CITY OF ALBUQUERQUE

Re: Fairfield, 4875 Pan America Freeway
Request for Certificate of Occupancy
Transportation Development Final Inspection
Architect's Stamp dated 10-27-15 (F17D006B)
Certification dated 12-1-17

Based upon the information provided in your submittal received 12-1-17,
Transportation Development cannot approve the release of Certificate of Occupancy
for the above referenced project.

Site Development Plan For Building Permit
Proposed 89 Room Hotel
4875 Pan American West Freeway NE
Albuquerque, NM
SHEET NO. **A001**

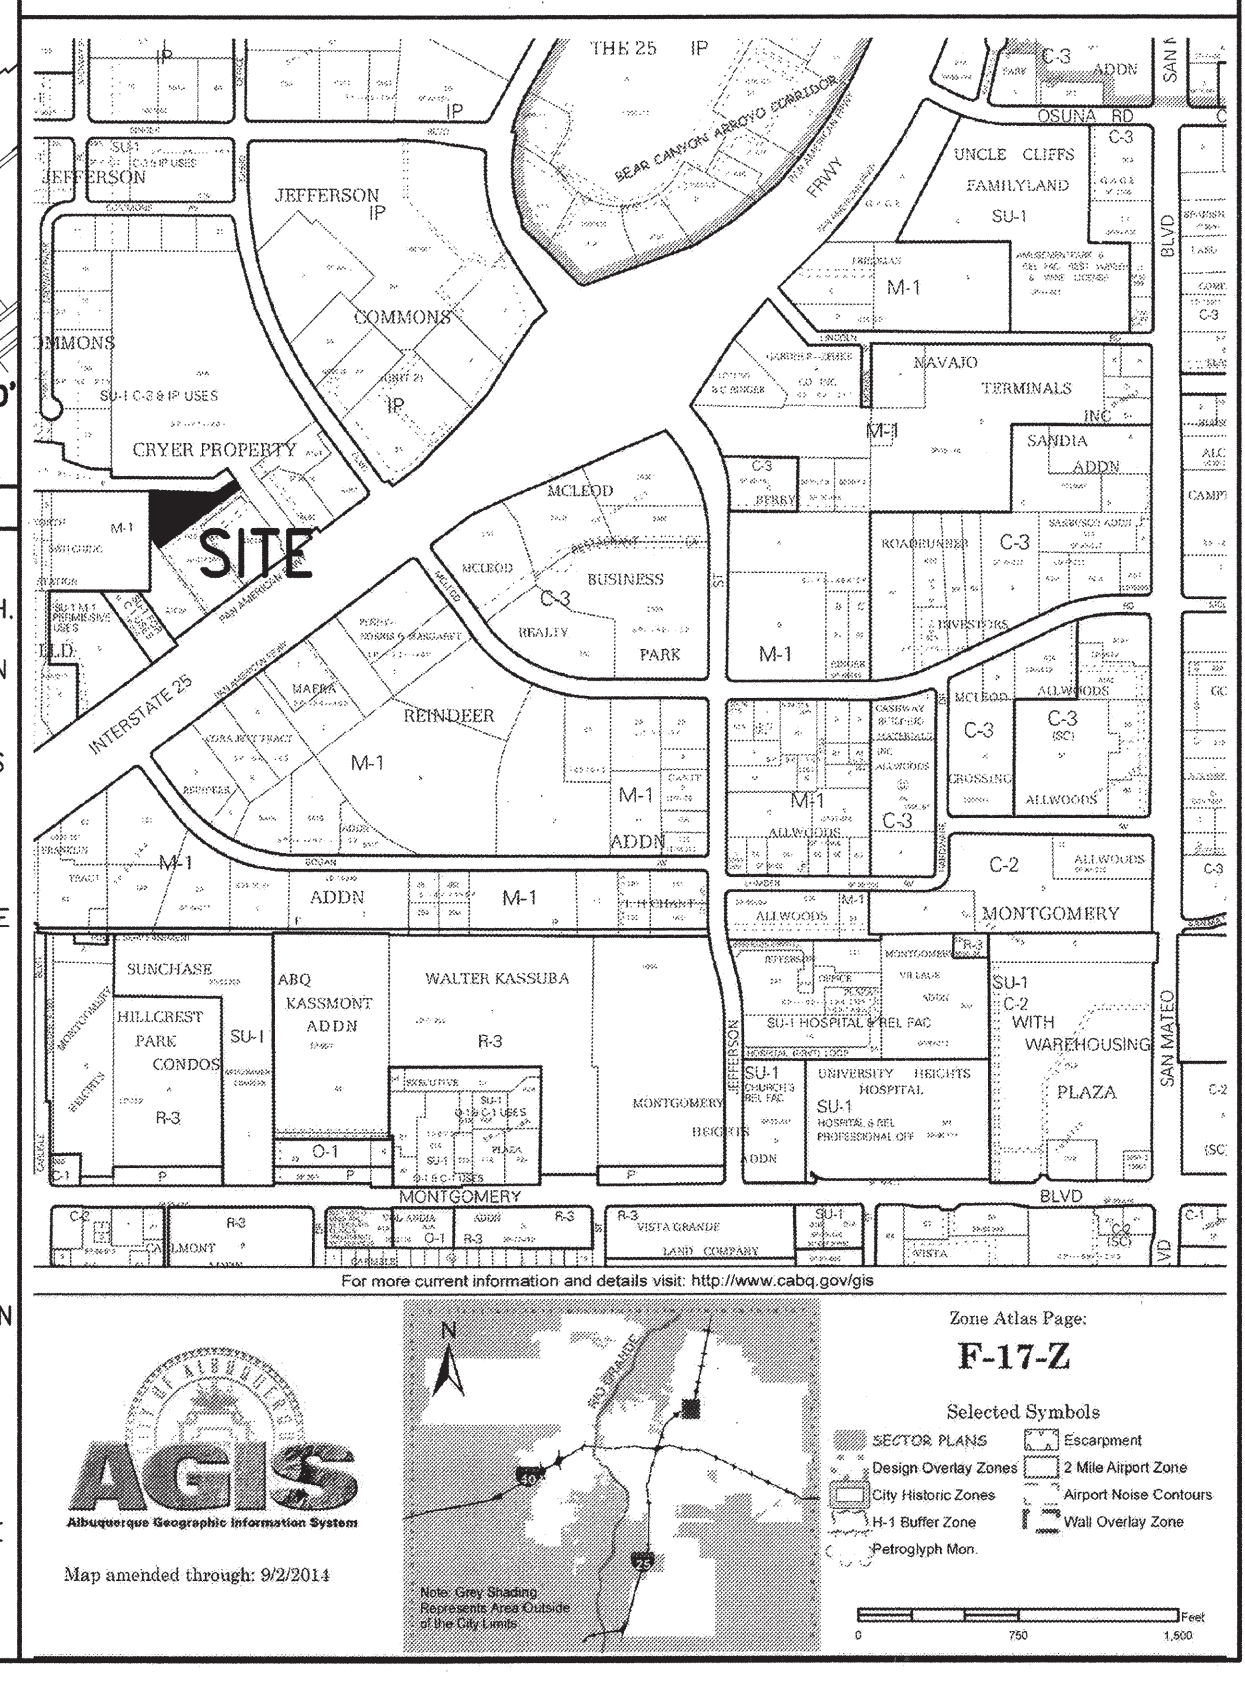
- Remove construction equipment and debris.
- Label the compact parking spaces by placing the words "COMPACT" on the
pavement of each space.
- The 6' pathway on the southeast side of the site has not been constructed per
the plan.
